Architectural Review
and Historic Preservation Board
Agenda Report

Meeting Date 2/18/15

Files: AR 14-05

RE: Recommendation to the Planning Commission Regarding a New CHP Facility
425 Southgate Avenue, APN 004-400-088

TREE MITIGATION PLAN &
LEGEND
DSA SUBMITTAL #1

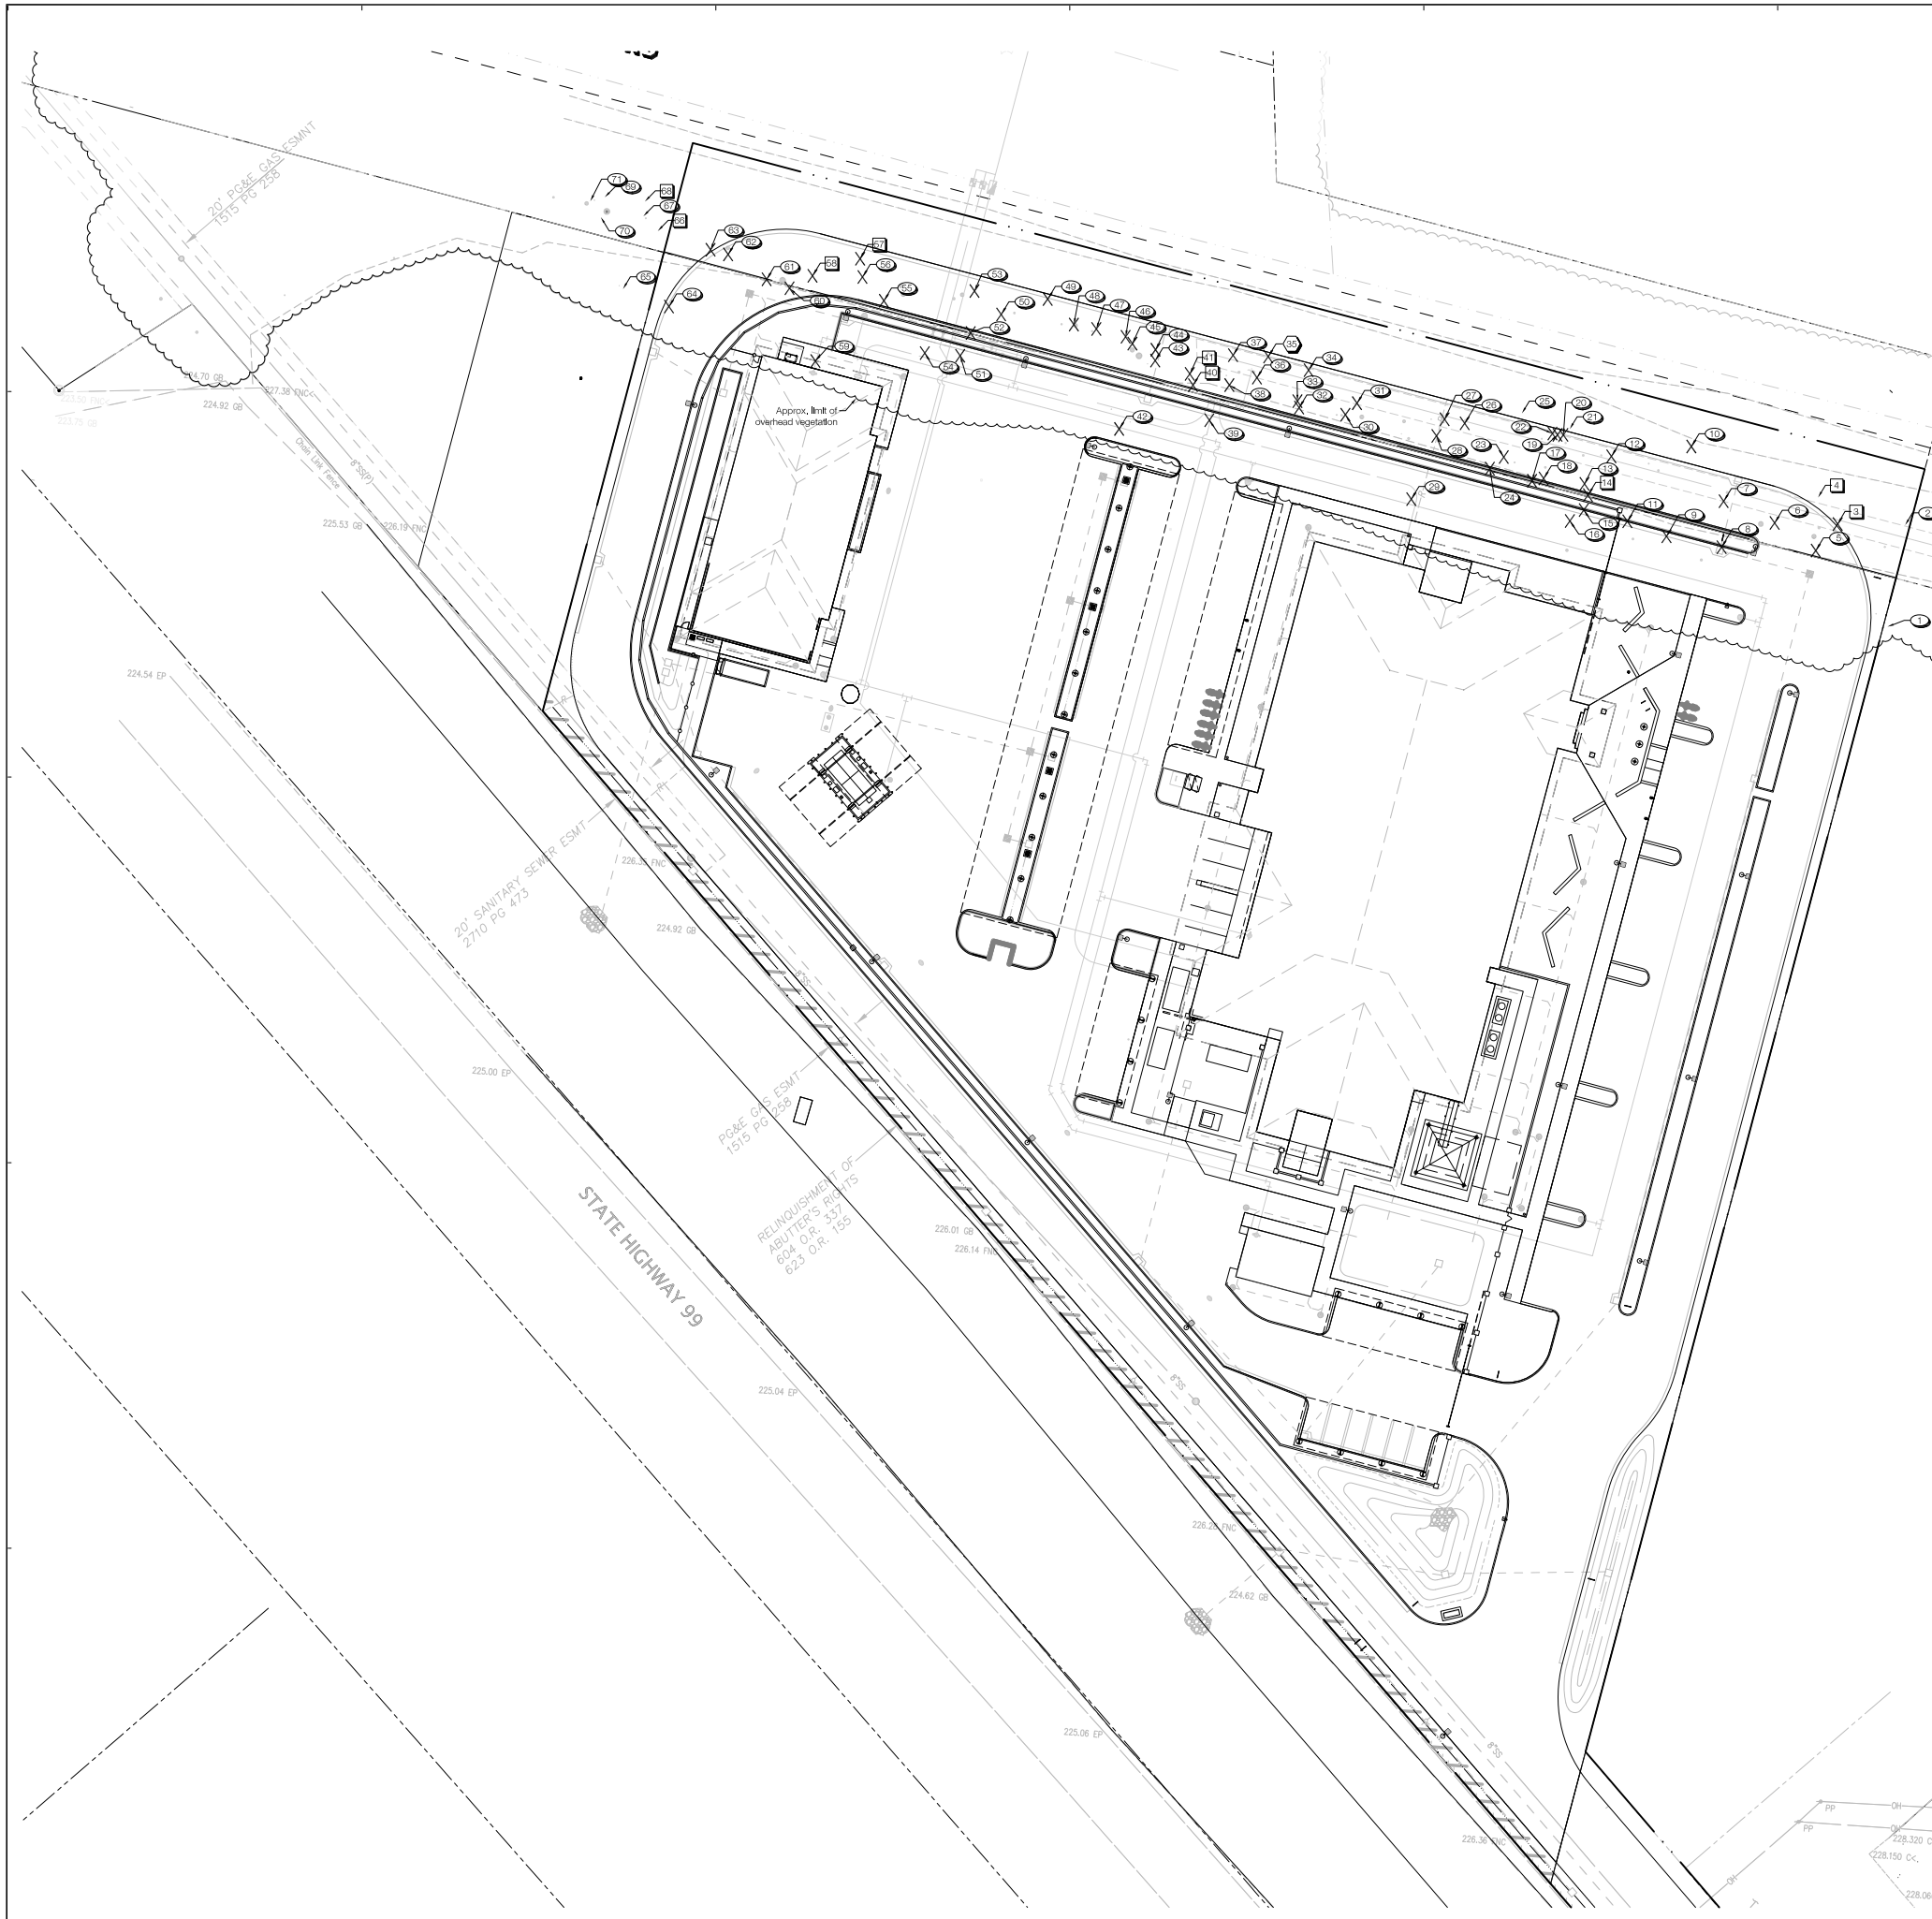
The proposed design would necessitate the removal of 58 of the 71 existing trees, primarily valley oaks, along the northern project boundary adjacent to the right-of-way for the future extension of Norte Dame Boulevard. All tree removal will be subject to City of Chico tree replacement requirements as established in Chico Municipal Code (CMC) Chapter 16.66.

Fifty-one of the 58 trees proposed for removal are valley oaks ranging in size from 6-inches to 36-inches in diameter at breast height (DBH). Many of the trees have structural defects, including most of the largest trees which are either forked very low to the ground or growing in pairs so close that their bark has merged together. Many of the smallest tree are severely slanted as a result of growing beneath larger trees. These defects limit their long-term viability. There are also several mid-sized to large oak trees with good structure.

If approved as designed, the project would remove a total of 729 inches of DBH, which corresponds to 124 replacement trees required by the City's Tree Preservation Ordinance (CMC 16.66). Some replacement trees would be planted at the project site to meet this requirement, while each remaining tree will require payment of an in-lieu fee that will be put toward maintenance of the City's urban forest. It is in this sense that existing regulations will aid project consistency with Policy OS-6 directing us to provide a healthy urban forest.

Tree Removal: Discuss with the applicant the possibility of modifying the design to preserve some of the trees proposed for removal. Condition the Board's recommendation as necessary to make the required findings.

SITE PLAN
PHOTOMETRICS

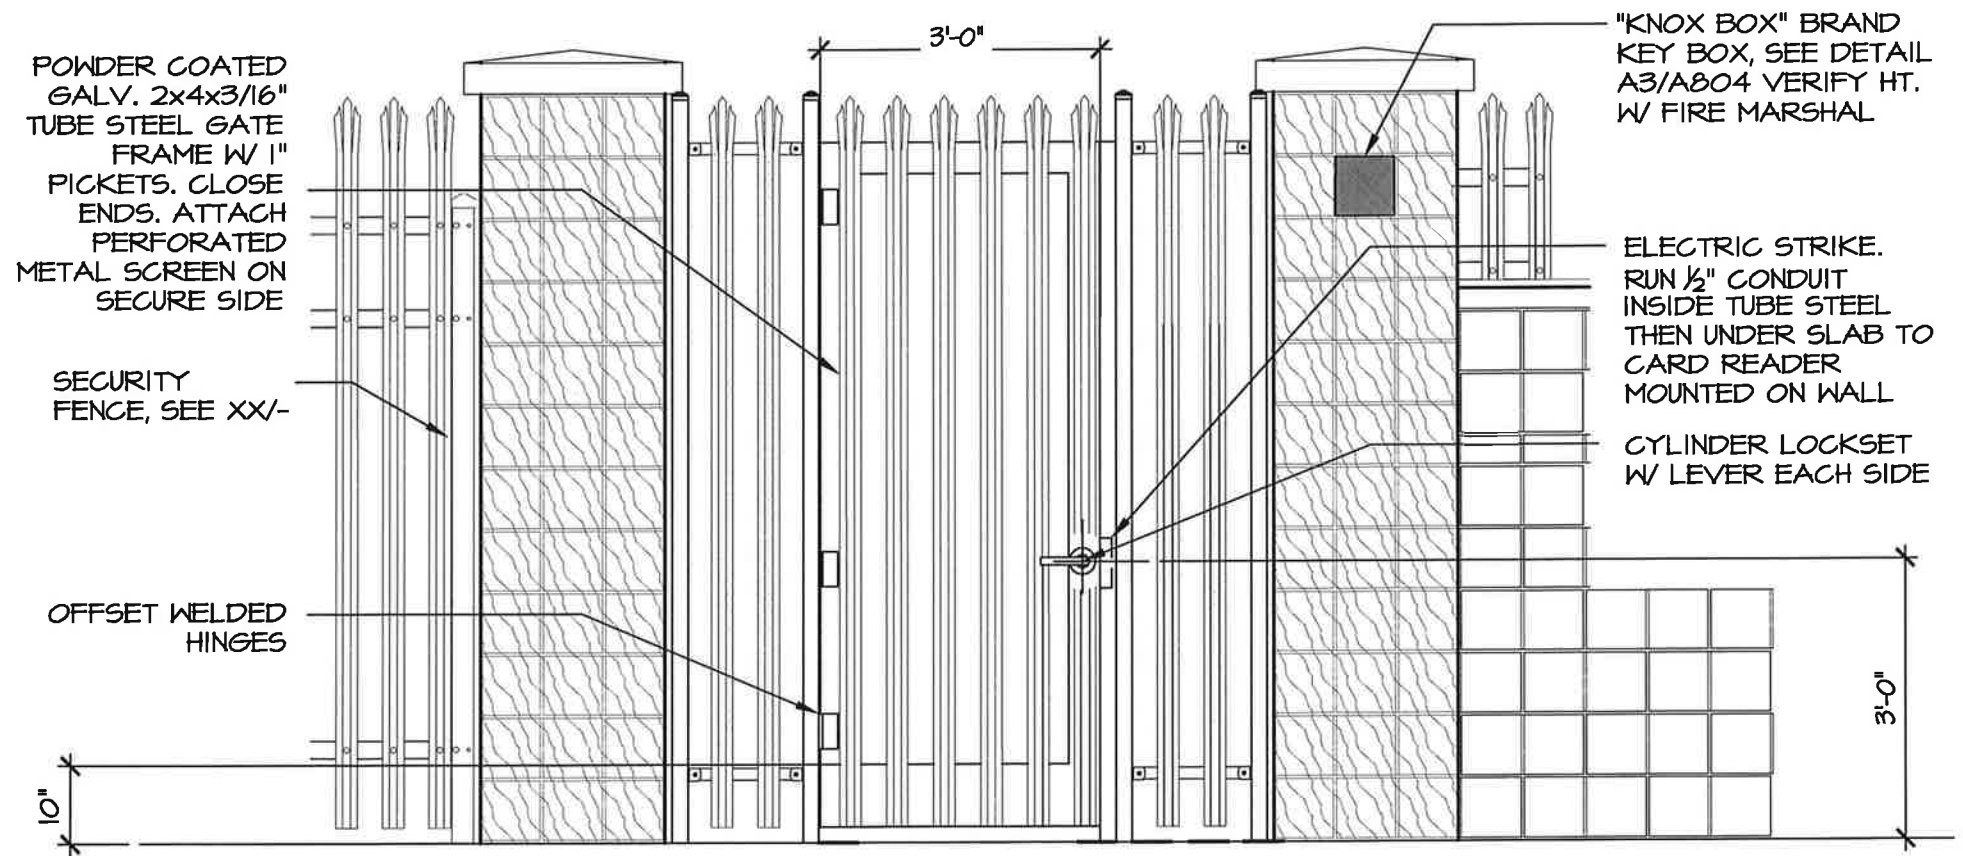
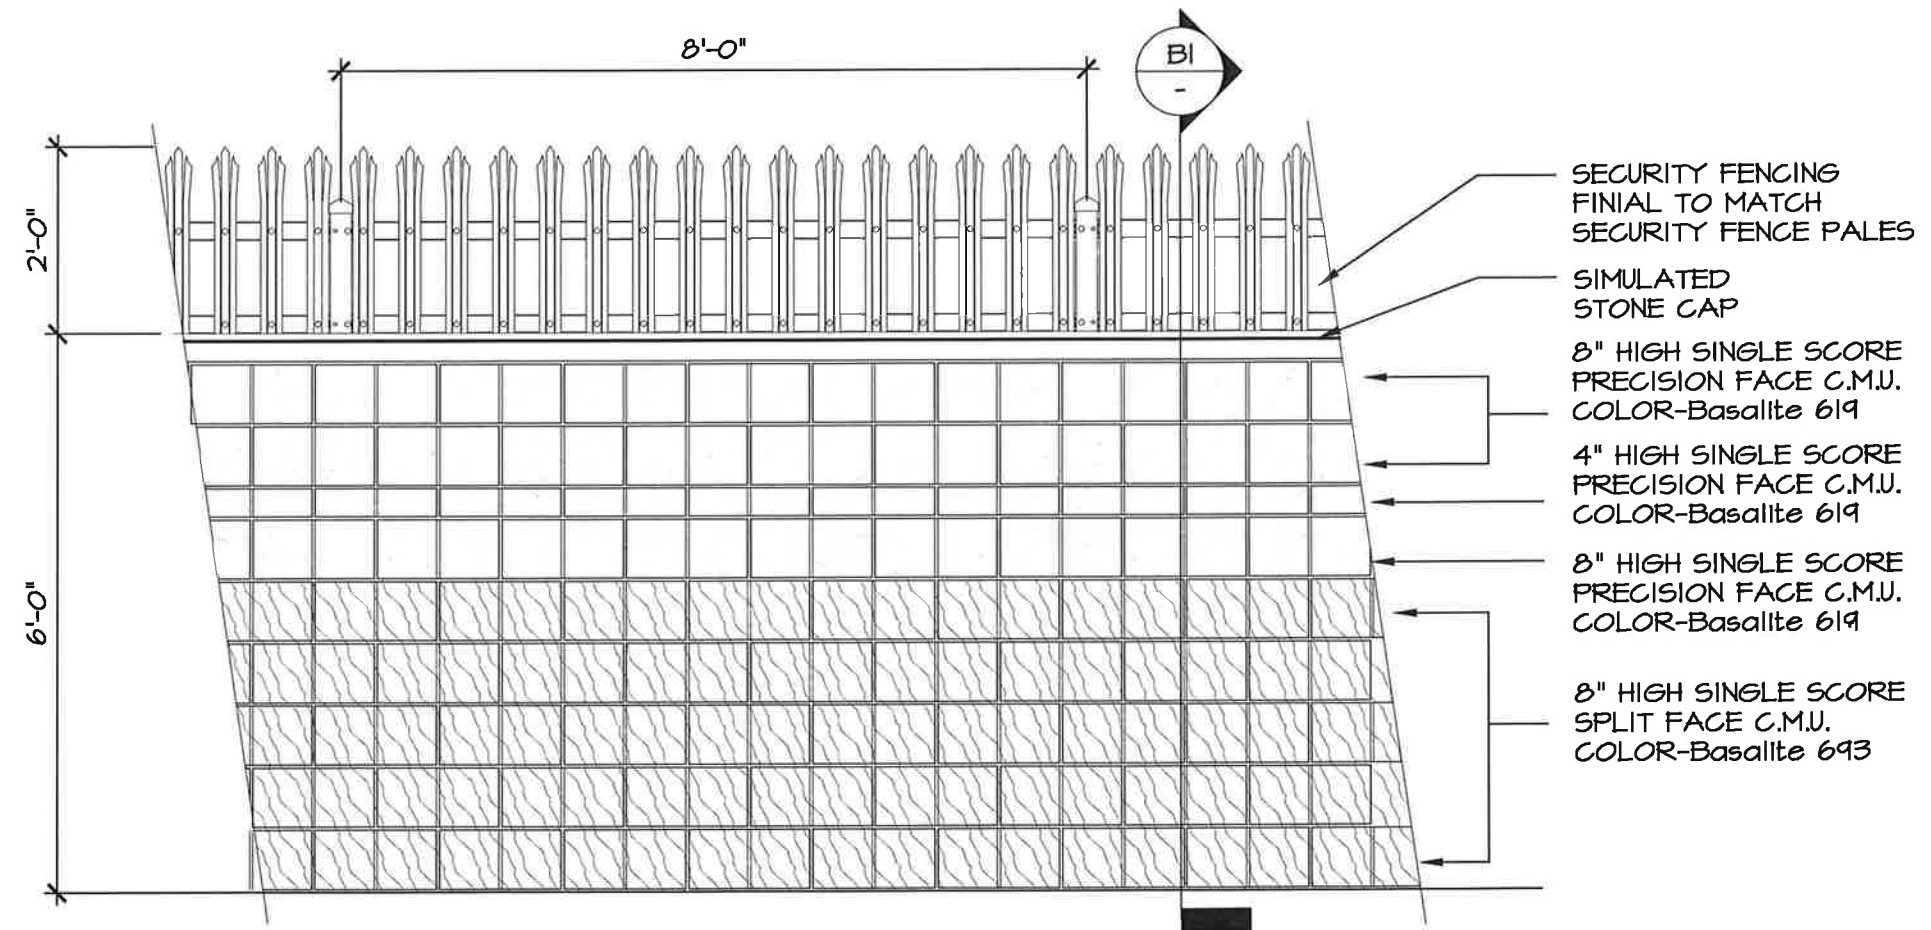
Parking lot light standards in regional commercial developments are typically limited to 16-18 feet. Light standards are proposed at 32 feet around the secure perimeter of the new facility. Limiting the height of light standards in typical parking lots serves multiple purposes:

- It minimizes glare into the night sky and onto nearby properties,
- It minimizes conflicts with shade trees in the parking area, which can grow to provide canopy coverage above a lower level of lighting,
- It helps meet zoning code requirements to confine light from new developments within the boundaries of the site and away from adjacent properties and public rights-of-way (CMC 19.60.050), and
- It achieves consistency with Policy OS-1.3, which calls for reducing excessive nighttime light and glare.

Recognizing that the fenced area behind the CHP main office has special security requirements and will have parking covered by photovoltaic arrays instead of trees, a

condition is recommended to permit parking lot lights up to a maximum height of 26 feet above grade. This condition is intended to strike a balance between accommodating the increased security needs of the facility and minimizing the visibility of bright lights close to the highway.

Parking Lot Light Standards: Discuss the appropriate maximum height that can be allowed for the light standards and modify recommended condition #3 if necessary.

3. The finished height of parking lot lights shall not exceed 26 feet above grade.
